Peka Peka to **ō**taki Expressway – Post Project Hydraulic Model Report

Revision 5

Aconex document number: T&T-DE-RPT-0017

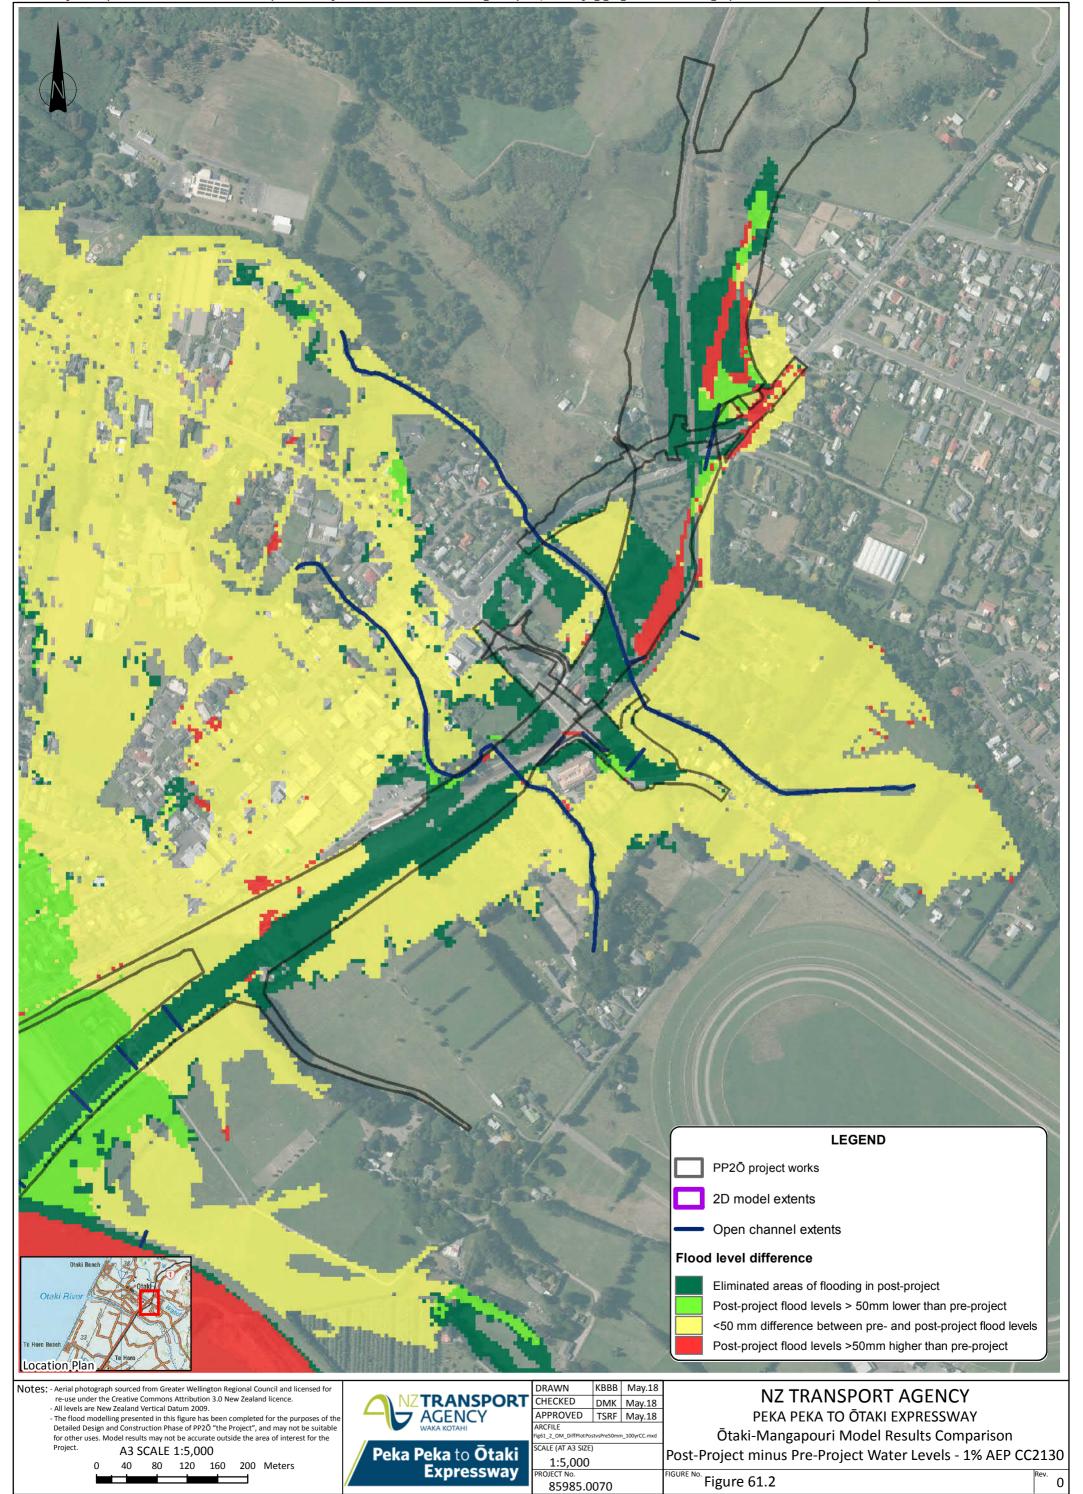
Figure 61.1 in Appendix A compares modelled flood levels in the pre- and post-project situations in the 1% AEP CC 2130 event. Pale green shading and dark green shading in Figure 61.1 indicate extensive areas through town where flood levels have decreased more than 100mm or flooding has been eliminated entirely in the post-project situation. Red shading in Figure 61.1 indicates areas with more than a 100mm increase in flood levels, which is predominantly confined to a few areas alongside the Ōtaki River.

Figure 61.1 demonstrates clear, significant benefits in terms of reduced flooding in the 1% AEP CC 2130 event. Consultation with relevant landowners about flooding effects will be required in areas with more than 100mm increase in flood levels (red shading in Figure 61.1) in line with consent condition SW.2 iii)c).

The areas of both dark green (eliminated flooding) and red shading (increases greater than 100mm) in Figure 61.1 are reduced compared with the previous iteration of this report, which assumed Chrystall's Stopbank would be upgraded to both the east and west of the expressway. The current Proposed Design (upgrade to east only) is preferred because, while it does not reduce flooding to the north of Sue Avenue as much as the previous design, the Proposed Design also does not increase flooding along the north bank of the Ōtaki River downstream of the existing rail bridge to the same extent. The Proposed Design does not preclude later upgrades to the stopbank to the west of the expressway.
